Access Compliance Report

Public Rights-of-Way

(Curb Ramps)

Intersection ID: 52931	Main Street: WALTHAM_LN	Cross Street: GRAY_OAK_LN	Location:	N
ADA ID: 4D8EDD5CA6DE	Ramp Type: Perp	Initial Pass/Fail: Pass	Overall Compliance: No	Severity Score: 0
Codes/Mitigation Info/Possible Solution		Field Measurements/Component Compliance

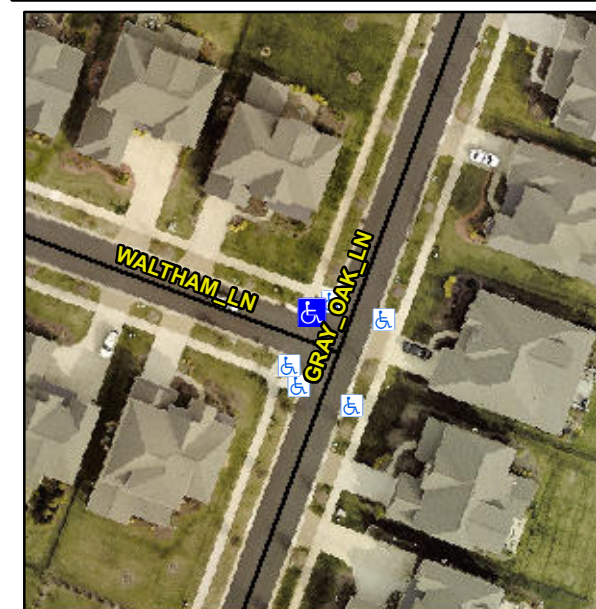
R304.5.3, R305.2

Compliance	Description	Data	Compliance	Description	Data
N/A	Ramp Length (in)	98.5	Yes	Ramp Slope (%)	7.8
Yes	Ramp Width (in)	58.0	Yes	Ramp XSlope (%)	0.7
N/A	Flare Type LT	Sloped	N/A	Flare Type RT	N/A
N/A	Flare Slope LT (%)	8.8	Yes	Flare Slope RT (%)	1.7
N/A	Flare Traversable LT?	Yes	N/A	Flare Traversable RT?	Yes
Yes	Landing Length (in)	61.5	Yes	DWS Provided?	Yes
Yes	Landing Width (in)	58.0	Yes	DWS Contrast?	Yes
Yes	Landing Slope (%)	0.9	Yes	DWS Length (in)	24.0
No	Landing X Slope (%)	3.0	Yes	DWS Full Width?	Yes
N/A	Landing Curb? (Y/N)	No	No	DWS Offset (in)	5.0
N/A	Shared Landing?	No			
Yes	Gutter Ponding?	No	Yes	Gutter Slope (%)	2.9
Yes	Gutter Lip Ht (in)	0.0	Yes	Gutter X Slope (%)	0.6
N/A	Painted X Walk1?	No	N/A	Painted X Walk2?	N/A
	X Walk 1 Direction	To SW		X Walk 2 Direction	N/A
N/A	X Walk 1 Width (in)	N/A	N/A	X Walk 2 Width (in)	N/A
	X Walk 1 Slope (%)	2.3		X Walk 2 Slope (%)	N/A
	X Walk 1 X Slope (%)	1.8		X Walk 2 X Slope (%)	N/A

N/A	Ramp inside XWalk1?	N/A	N/A	Ramp inside XWalk2?	N/A
	Road Slope (%)	N/A	N/A	Clear Space?	Yes
	Road X Slope (%)	N/A	N/A	Clear Space to XWalk (in)	N/A
Yes	Any Obstructions?	No	Yes	Storm Grate/Utility Hazard?	No
	Obstruction Type			Storm Grate/Utility Type	
		N/A			N/A
			Yes	Surface Condition? (G/P)	Good

Remove & Replace Entire Ramp.
